Land at Oakley Farm, Cheltenham 24/00251/CONDIT

The Friends of Oakley Farm Pasture Slopes – Response-2 to Planning Application 24/00251/CONDIT.

Fig 1. Main Access Road Vertical section

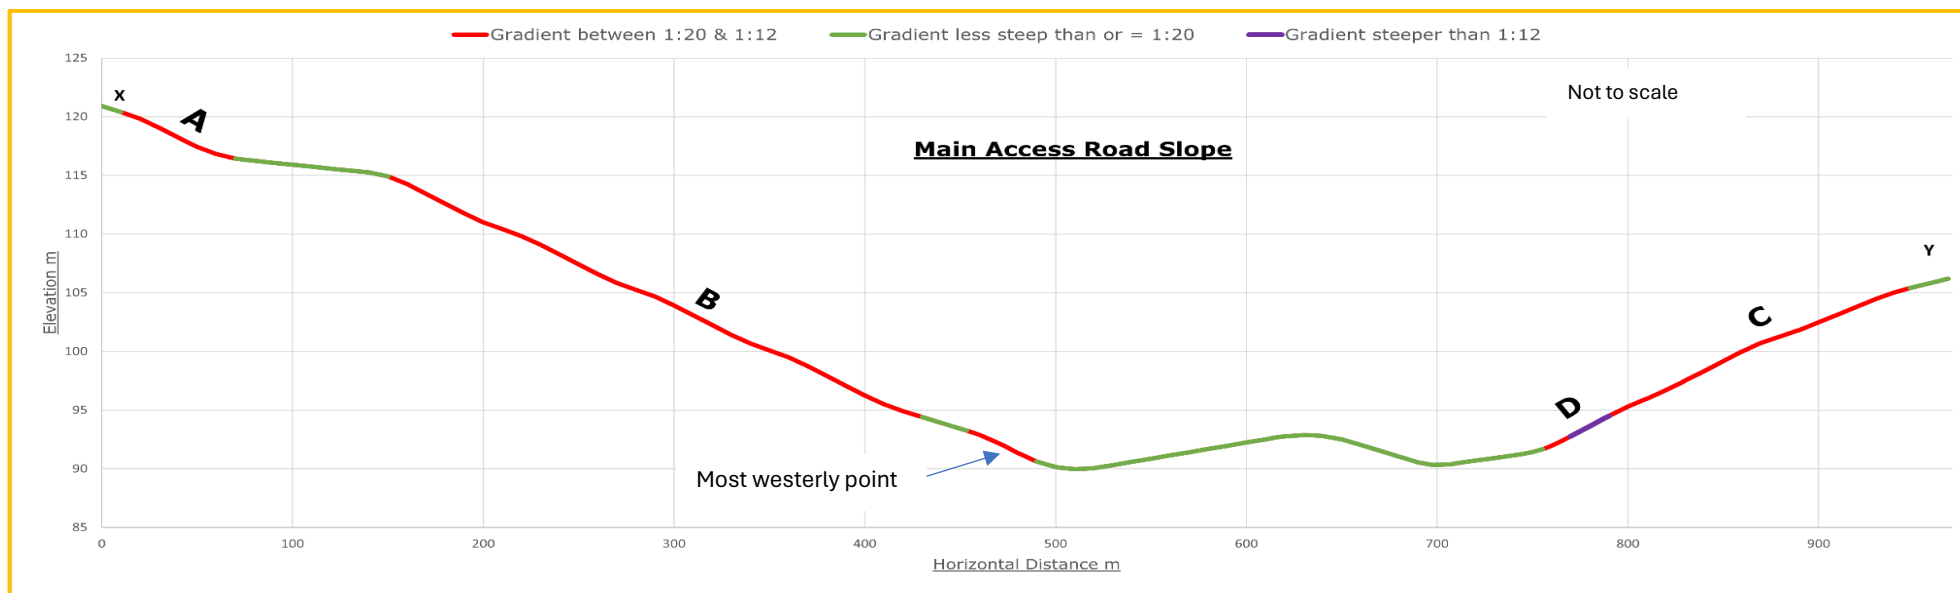
15. The gradients of the main access route are not in general accord with the maximum gradient of 1:20 as conditioned. They exceed this maximum for c56% of the total road's length. See figs. 1&2.

16. c20% of the main access road is proposed with gradients at the "ultimate maximum"² of 1:12. See figs. 1&2. Again, highlighting not in general accordance as conditioned.

Figures 1 & 2 shown below, highlight 4 zones where the gradients are non-compliant with condition 13.

Zone A: Road section, 40m in length with an average gradient of 7.5% or 1:13.3

Zone B: Road section, 270m in length with an average gradient of 7.41% or 1:13.5

Zone C: Road section, 150m in length with an average gradient of 7.03% or 1:14

Zone D: Road section, 40m in length with a gradient of 8.33% or 1:12. Within the 40m section is a 24.5m length with a gradient of 8.62% or 1:11.6. Also, non-compliant with MfGS.

- Green sections represent road segments compliant with Condition 13.
- Red sections indicate road segments with gradients between 1:20 and 1:12, extending for more than 30m, thus non-compliant with Condition 13.
- Purple sections denote road segments where the gradient exceeds 1:12, also rendering them non-compliant with Condition 13 and MfGS

Approximately 56% of the road's total length surpasses the conditioned maximum gradient of 1:20, while 20% of the road features a gradient of 1:12.

Fig. 2. Main Access Road Horizontal layout.

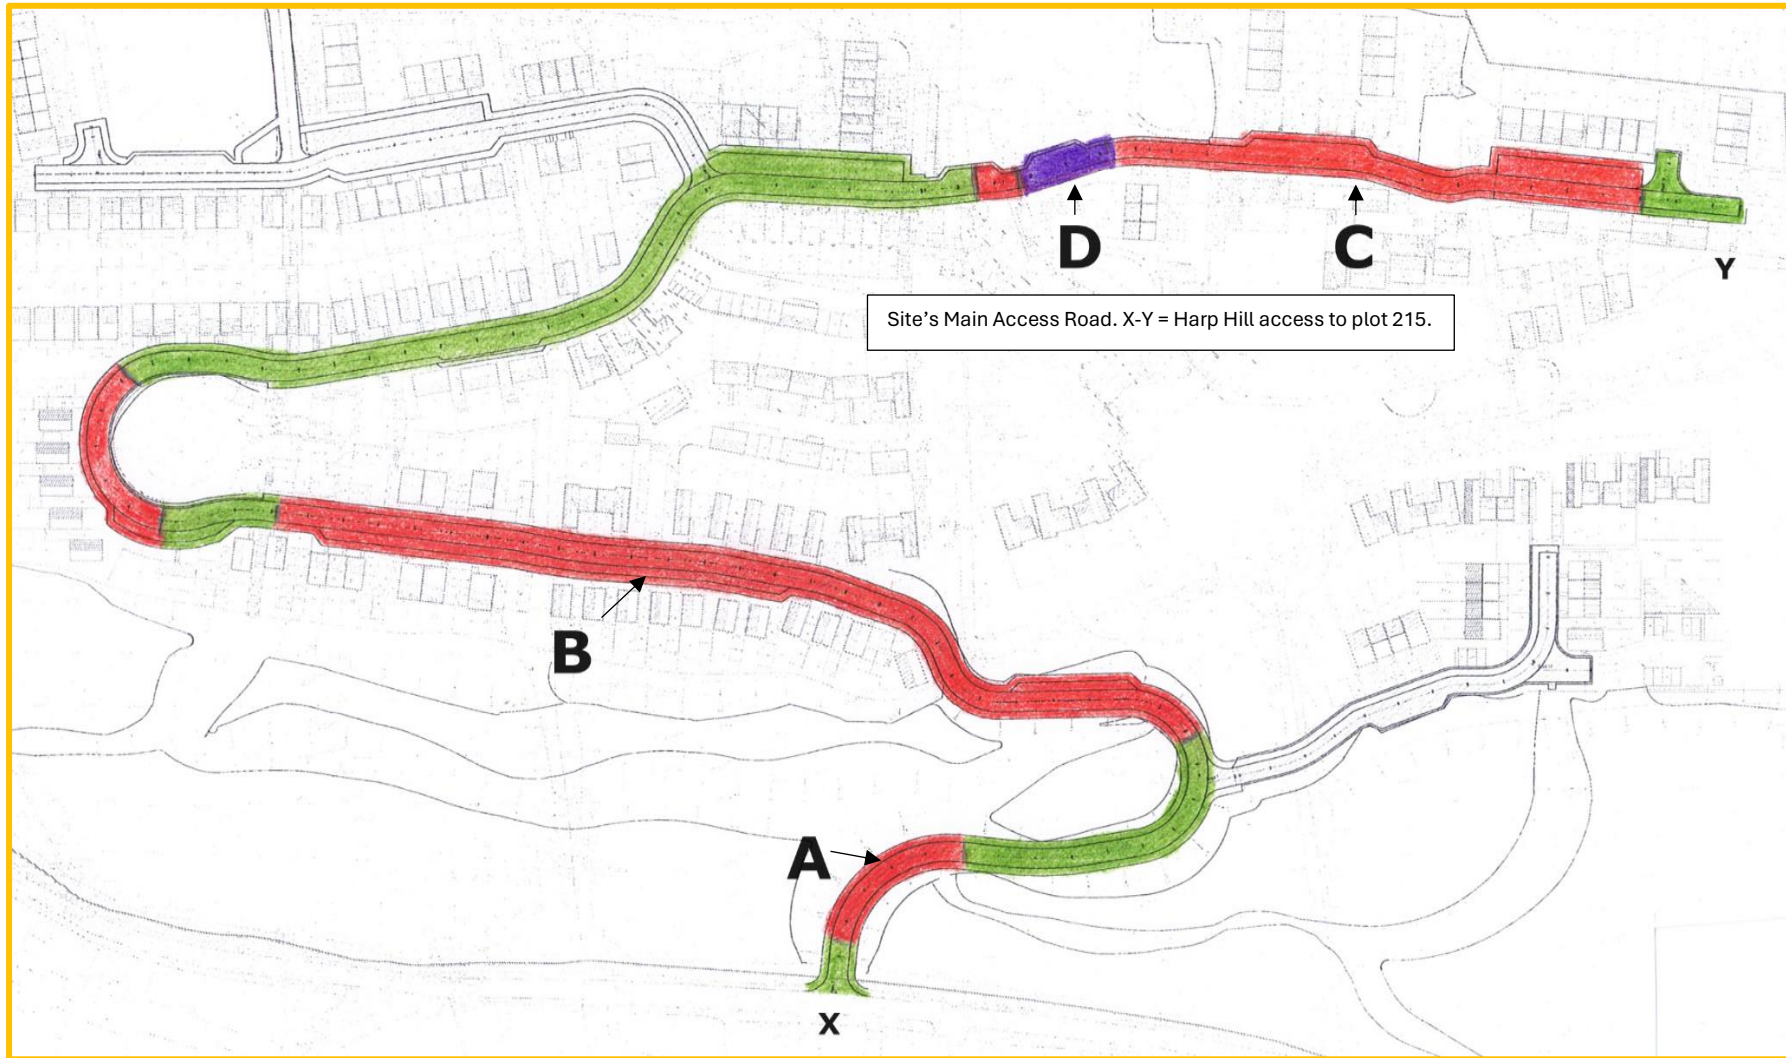
Road divided into zones corresponding to those shown in as fig. 1

Fig. 3. Extract of “Zone D” detail from Applicant’s Longitudinal Section Drawing. Evidence of non-compliance with both Condition 13 and MfGS.

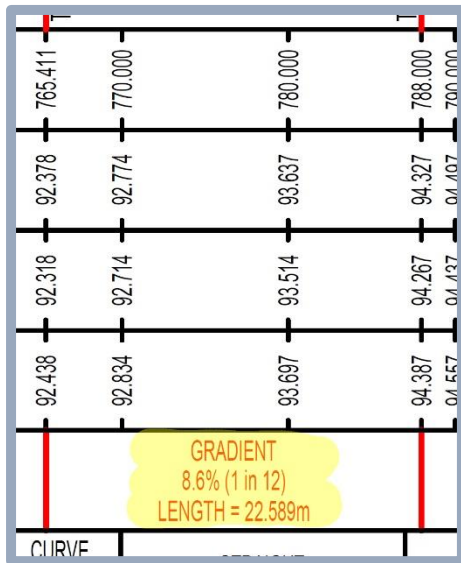
⁶ Between 765.411m and 790m a c25m section is shown as 8.6% this is equal to 1:11.6 and not the claimed 1:12. Exceeding the maximum gradient. See Fig. 3 below.

Taken from the applicant’s Access Strategy Longitudinal Sections diagram, this segment demonstrates further non-compliance with Condition 13. The depicted area corresponds to what we’ve identified as zone D. It presents a road section measuring 22.589 meters in length, featuring a gradient noted as 8.6% (1:12). However, when properly converted without rounding, 8.6% equates to 1:11.63. Zone D surpasses the prescribed 1:12 (8.33%) maximum stipulated by the condition. Furthermore, there’s an argument for the overall non-compliance of Zone D due to its total length of 40 meters at an average gradient of 8.33% or 1:12. Detailed figures for Zone D are outlined in Table 1 below. Notably, Zone D also fails to comply with the MfGS standards.

Gradient above should read: 8.6% (1:11.6)

Evidence of non-compliance with both Condition 13 and MfGS. Average gradient between 760m-800m of 8.33% (1:12) for 40m within which 25m at 8.6% (1:11.6).
